**Subject:** FW: Daedalus Dust Management Plan

**From:** [REDACTED]@campbellreith.com  
**Sent:** 24 May 2017 15:54  
**To:** [REDACTED]  
**Cc:** daedalusphase1@campbellreith.com; [REDACTED]; Jeremy Herring;  
[REDACTED]  
**Subject:** 12575 - Daedalus Waterfront - Planning Meeting Update

**DEMOLITION CONTRACTORS ACCESS & STOCK PILES.**

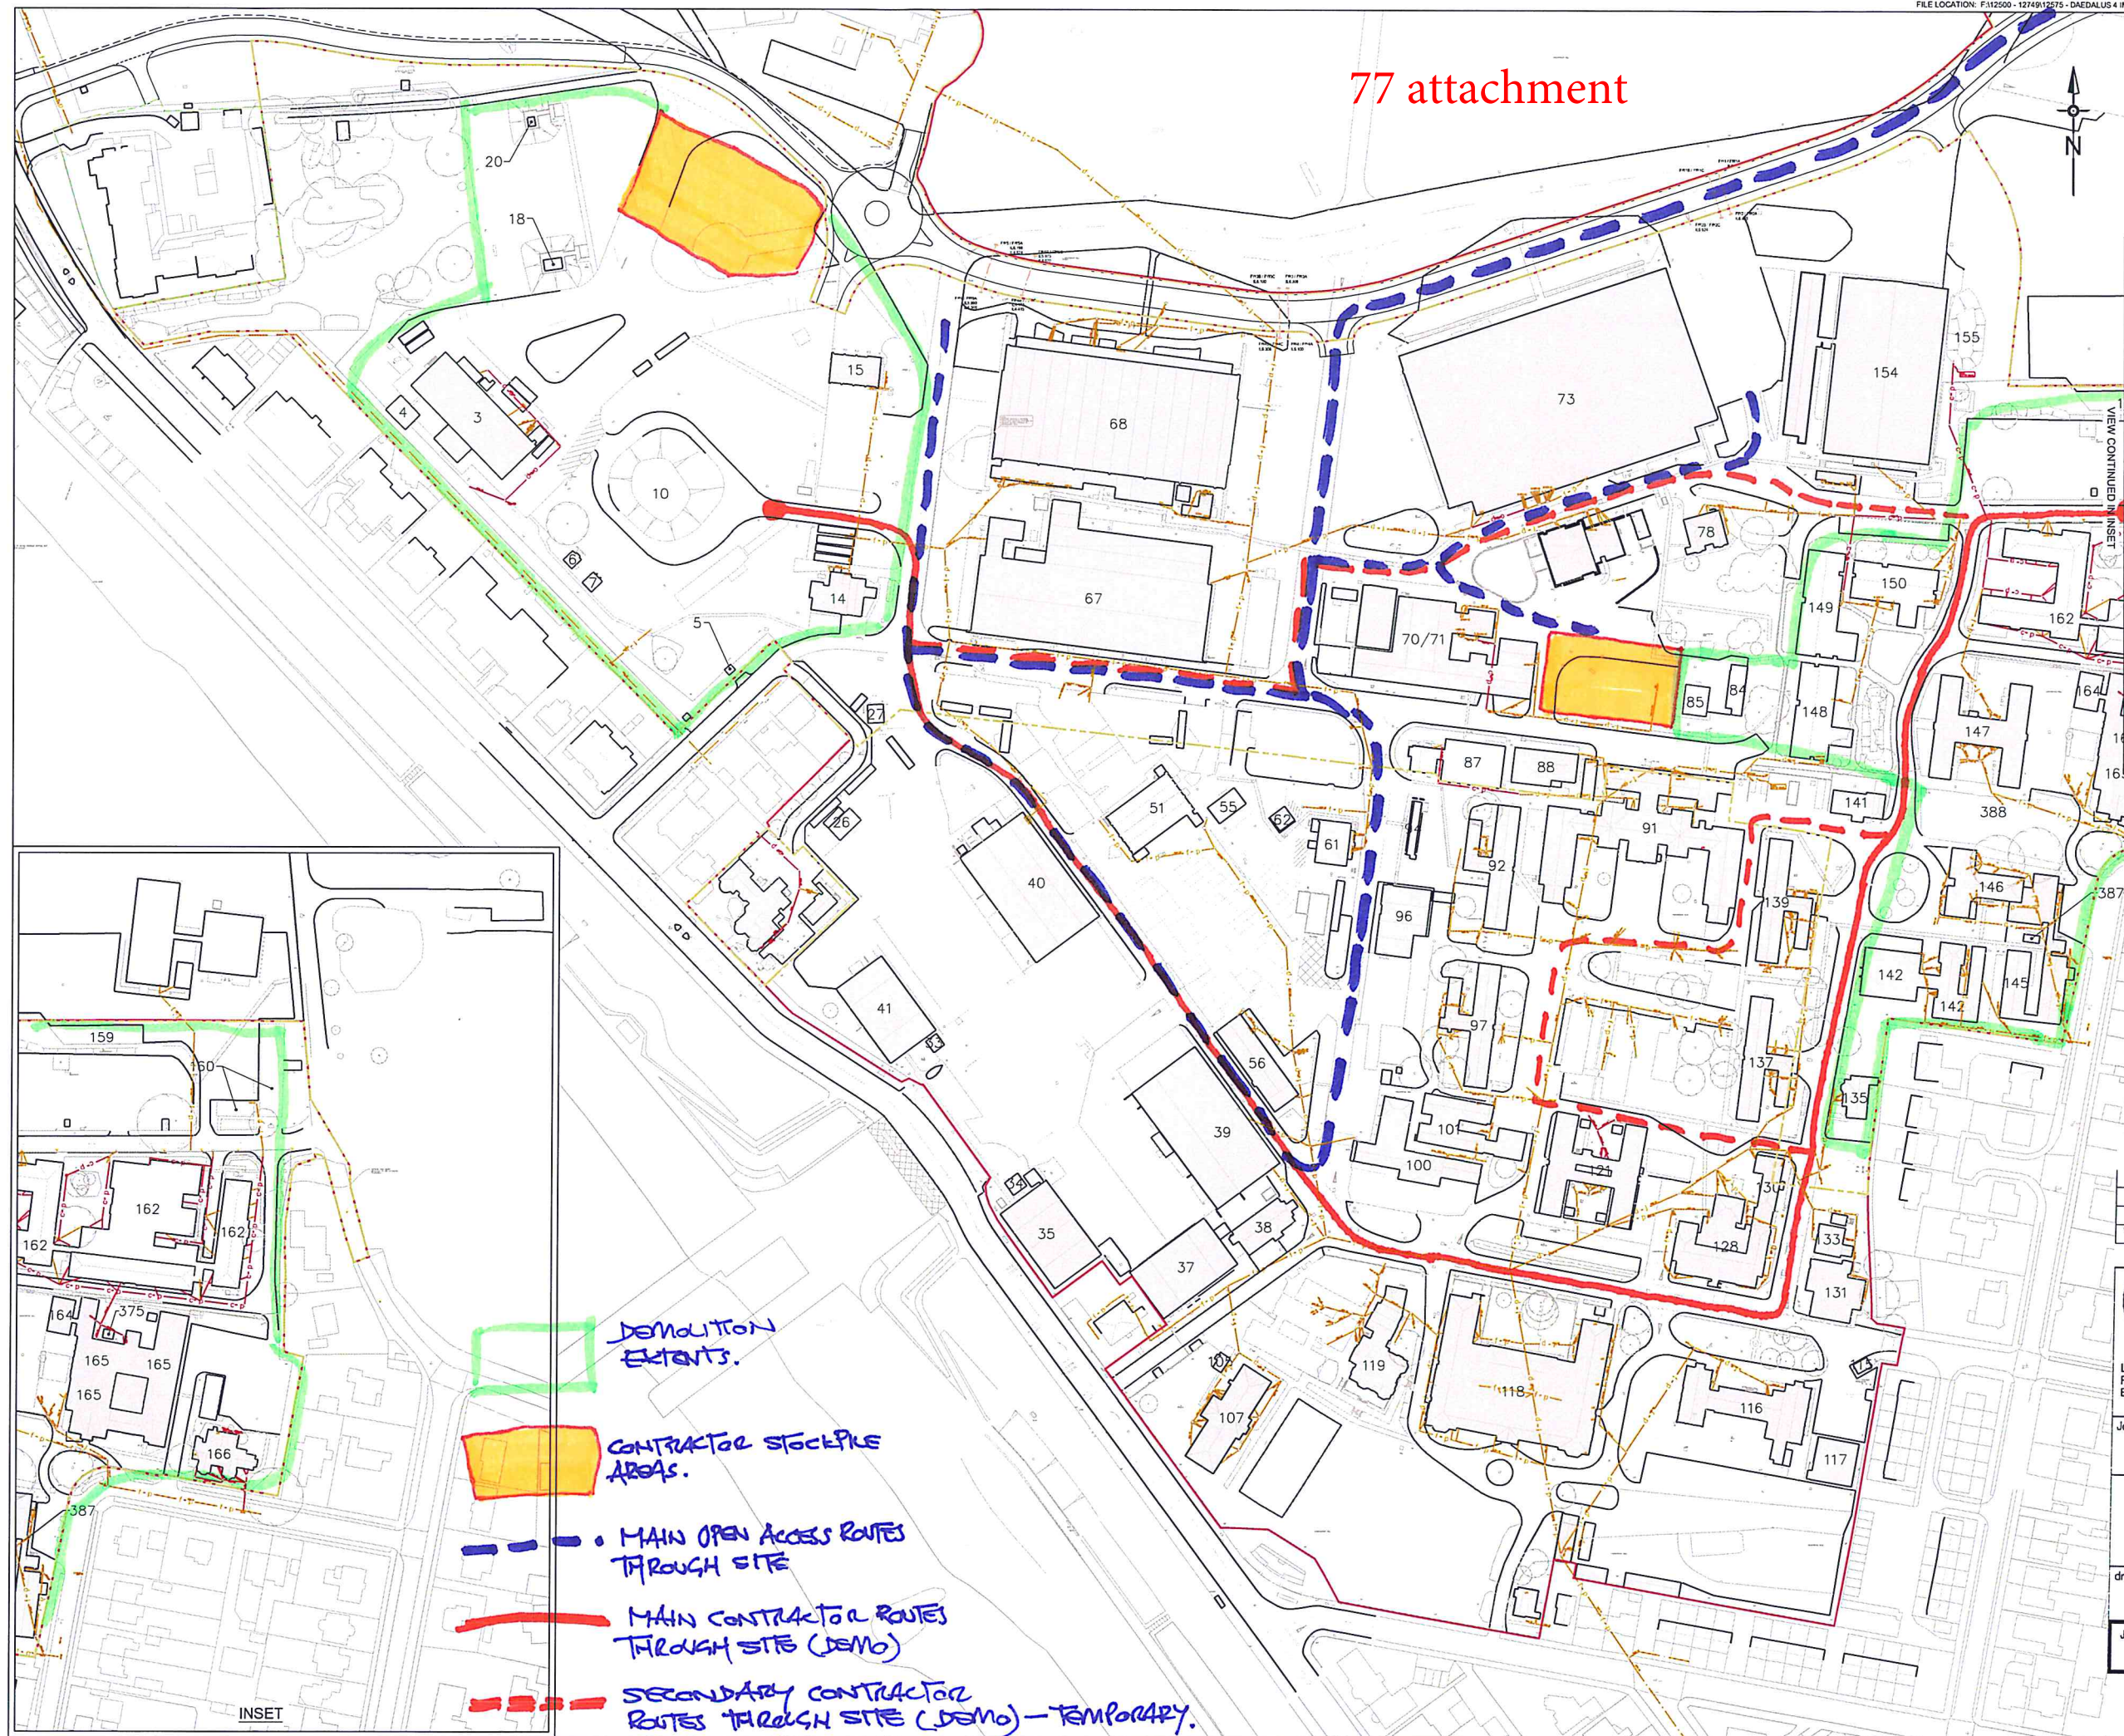
Please find attached a mark-up showing the main site access ways through site (blue) and the demo contractors main access routes, secondary and main (red). This plan also shows the updated stockpile locations.

DRAWING TITLE  
Construction phase compounds and stockpiles

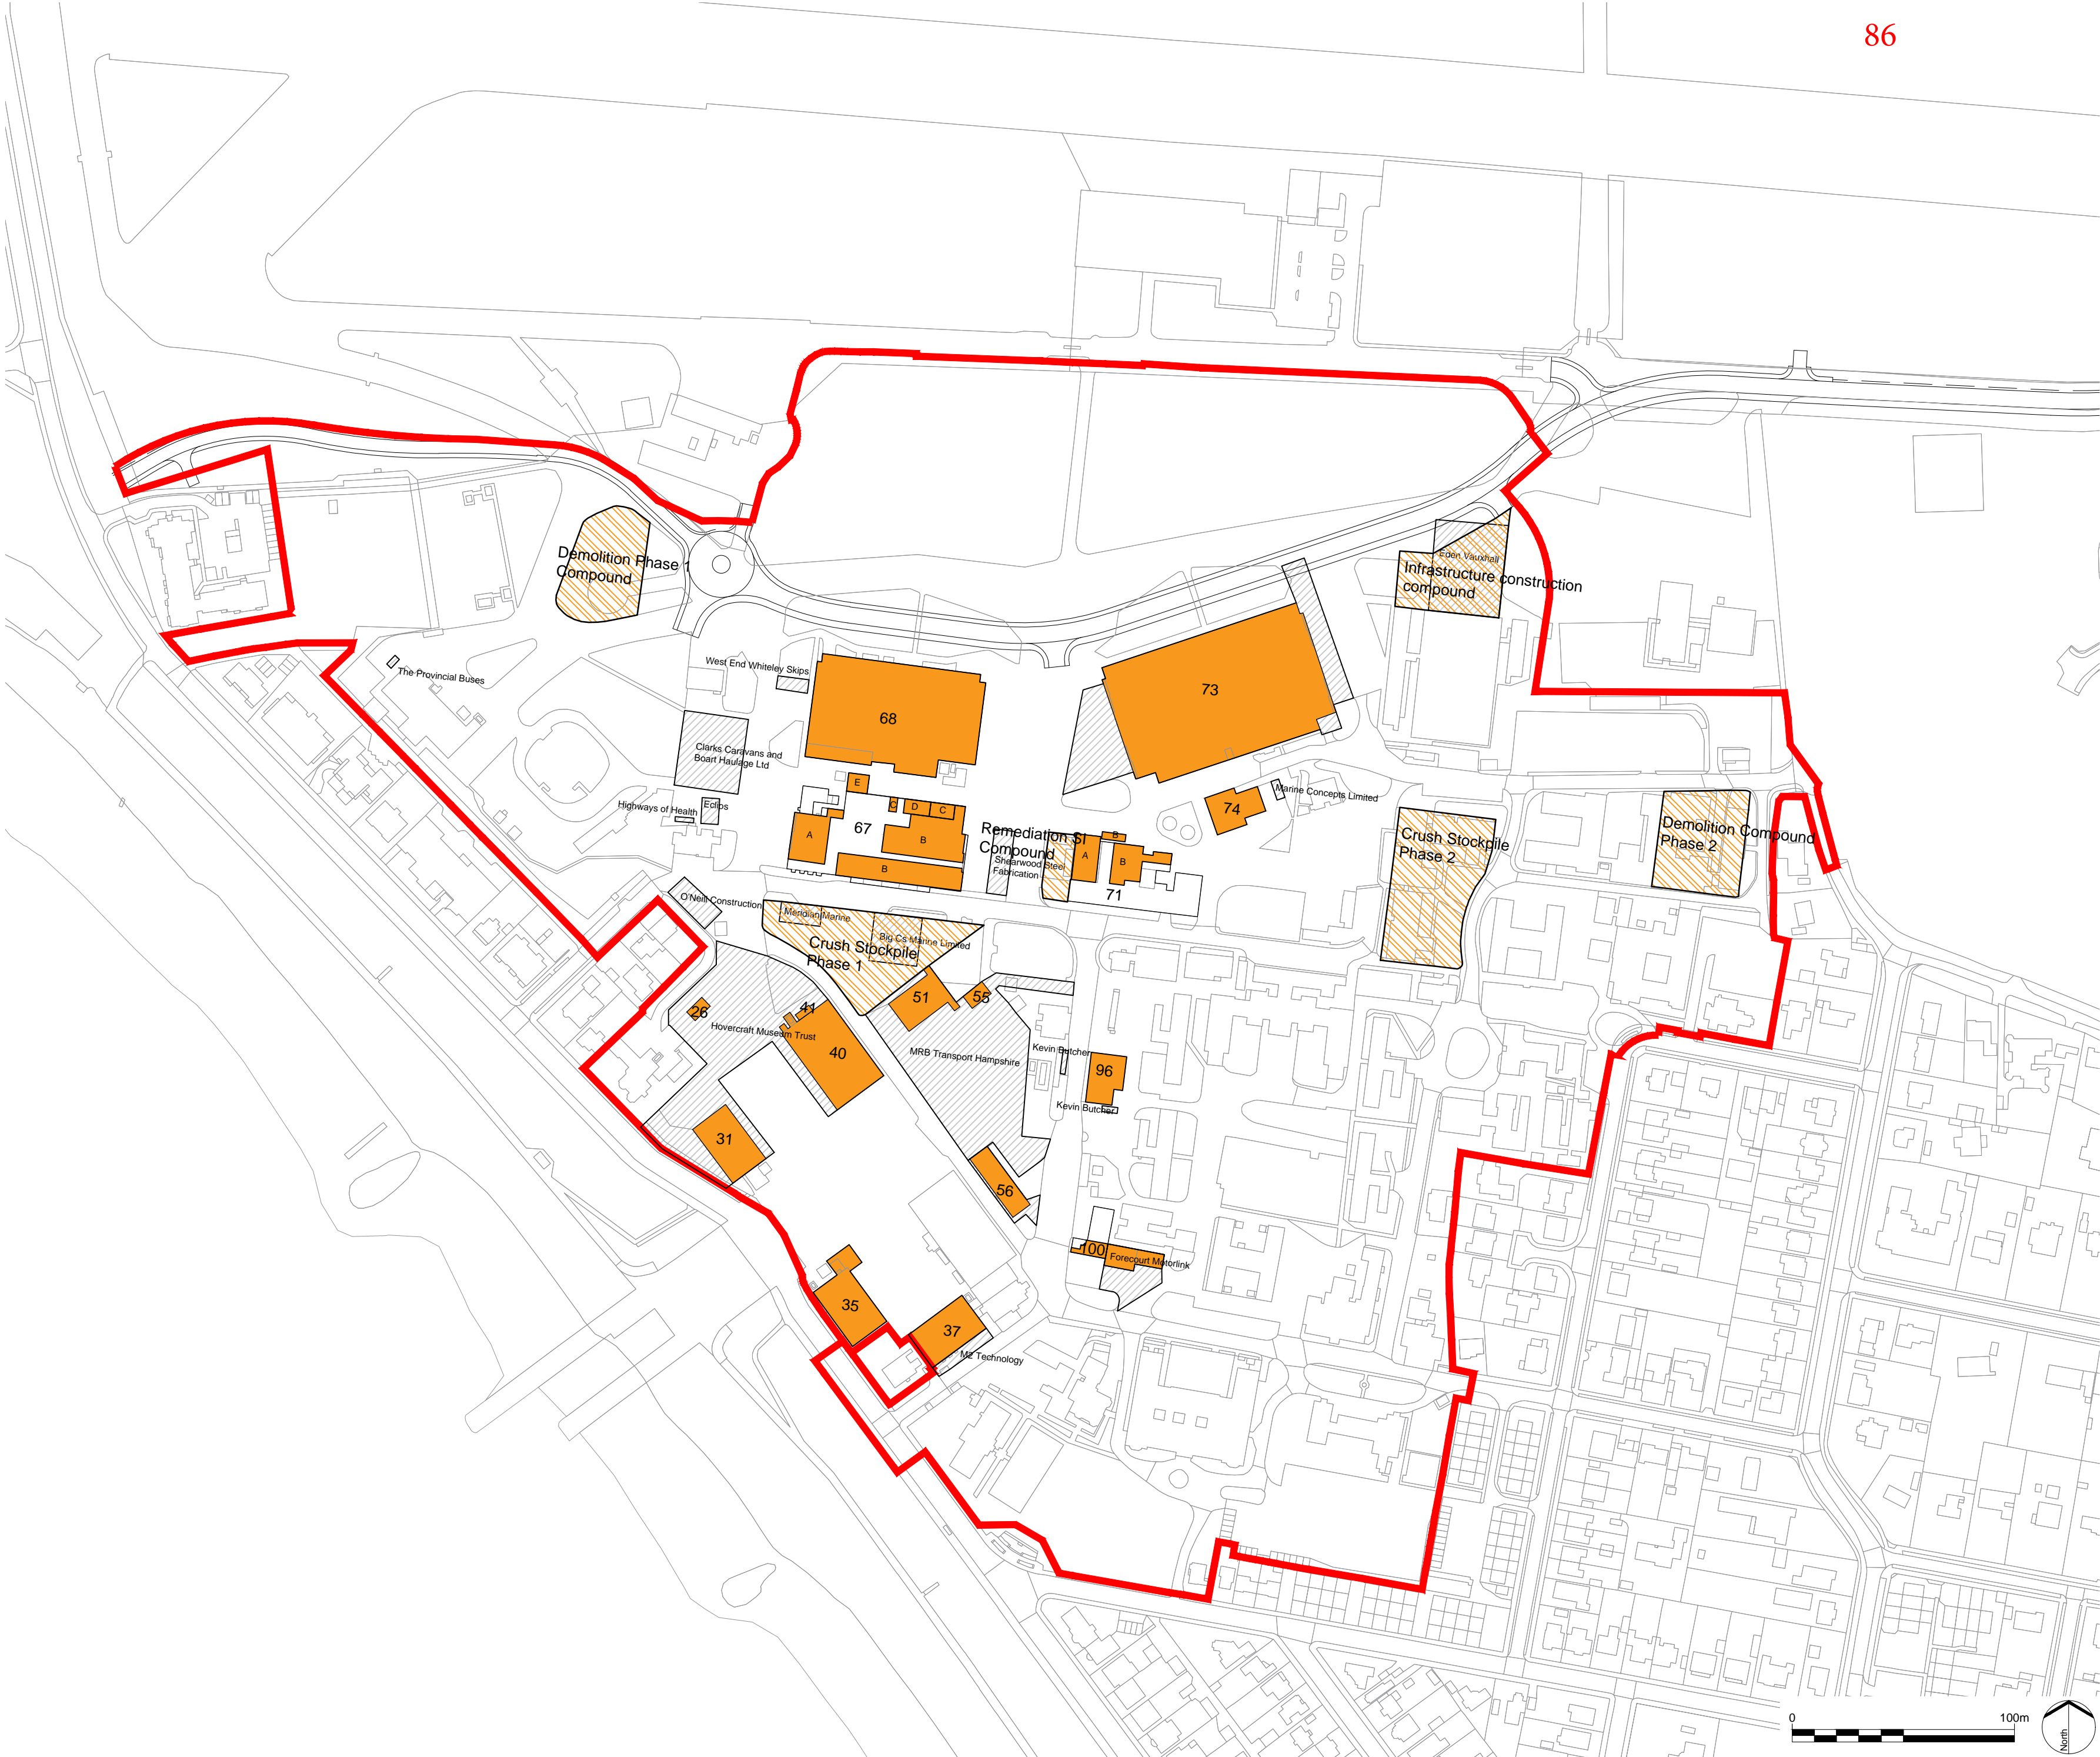
The issue that I believe is being complained about is that there is a large volume of uncrushed material in the western end of C2 as shown above. As [REDACTED] says this is temporary storage prior to crushing and long term storage.

[REDACTED] has confirmed to me on the phone just now that the crushing will start eating into that pile in the next few days, and will be complete within 2 weeks.
